HISTORIC AND DESIGN REVIEW COMMISSION

June 17, 2015

HDRC CASE NO: 2015-109
ADDRESS: 1115 S ST MARYS
LEGAL DESCRIPTION: NCB 2963 BLK 11 LOT S 95 FT OF A19
ZONING: C2 H HS
CITY COUNCIL DIST.: 1
DISTRICT: King William Historic District
LANDMARK: House
APPLICANT: Arturo Rivera
OWNER: Roberto Medrano
TYPE OF WORK: Construction of additional driveway and fence replacement
REQUEST:

Proposal

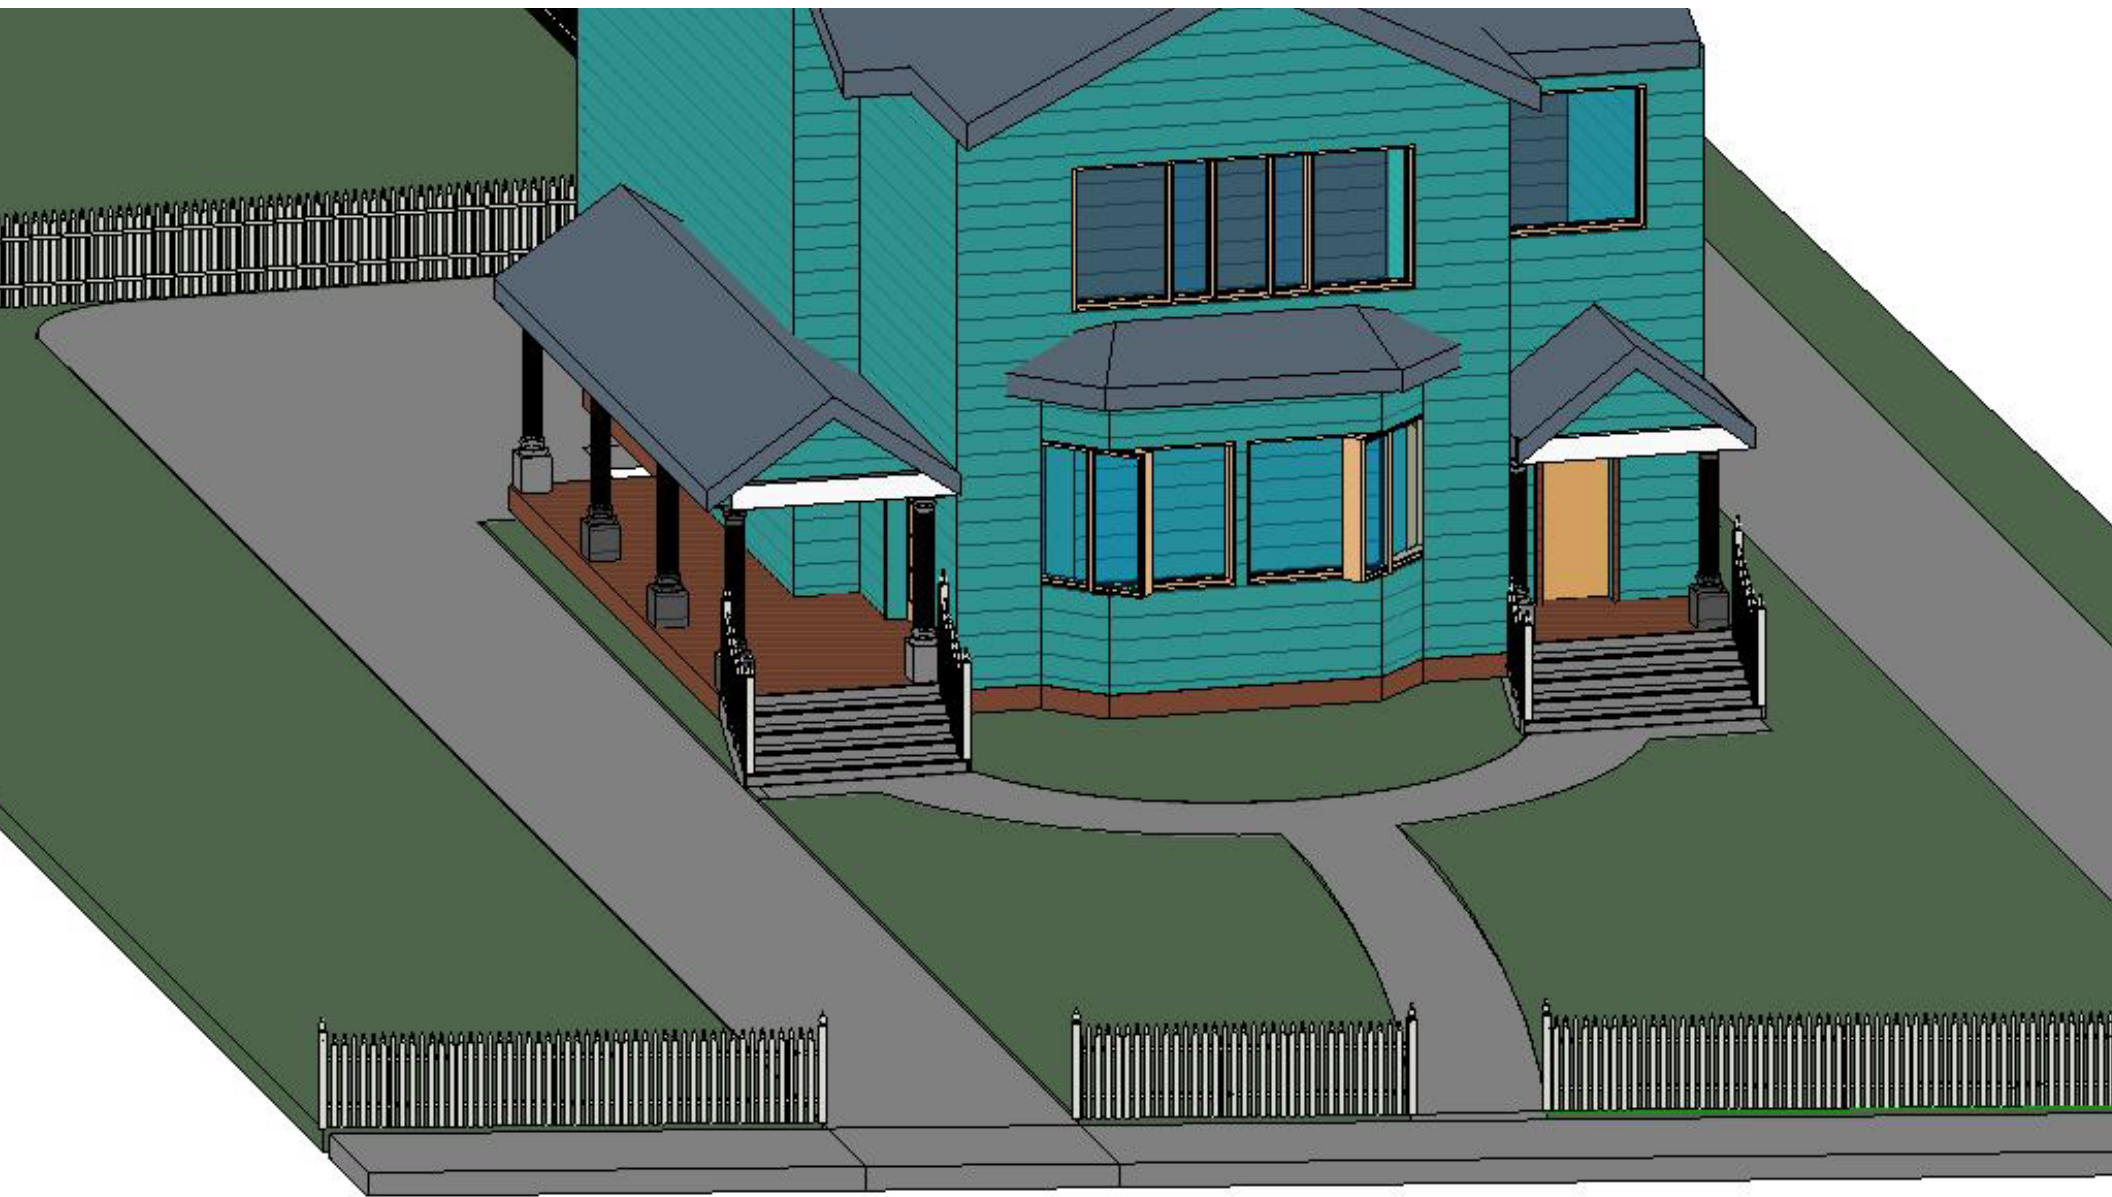
- c. The applicant has proposed to construct a driveway of crushed granite that is to extend from the existing rear parking lot to the front yard where an additional curb cut will be needed for access to S St Mary's. The applicant has proposed for the new curb cut to be ten (10) feet in width to match the existing. The Guidelines for Site Elements 5.B.i. states that historic driveways are typically no wider than 10 feet and that a similar driveway configuration regarding materials, width and design should be used that would be historically found on the site. The applicant has proposed a paving system of crushed granite for the proposed driveway. The applicant's proposal for an additional driveway is consistent with the Guidelines for Site Elements. Staff's recommendation for approval of the proposed driveway as well as curb cut is in regards to the historic context of the property.

- e. The applicant has noted that entrance and exit signage is to be installed with the proposed circular driveway, but has not specified the design of these signs nor the location. The applicant should provide staff with more information regarding the proposed signage to ensure that it is consistent with the Guidelines for Signage.

BF: STRAIGHT DRIVE IS A GOOD SOLUTION

IS: INCLUDE LABELED FENCES, EXISTING AND PROPOSED

JI: CRUSHED/DECOMPOSED GRANITE DRIVEWAY IS BEST, SHOW LANDSCAPING
ON PLAN.

ADD GRAPHICS TO SHOW NEW AND EXISTING
FENCE

Staff recommends approval of items #1 through #4 based on findings a through e with the following stipulations:

- i. That the applicant provide staff and the HDRC with more information regarding the proposed signage.
- ii. That the proposed white picket fence is no taller than four (4) feet tall at any location.
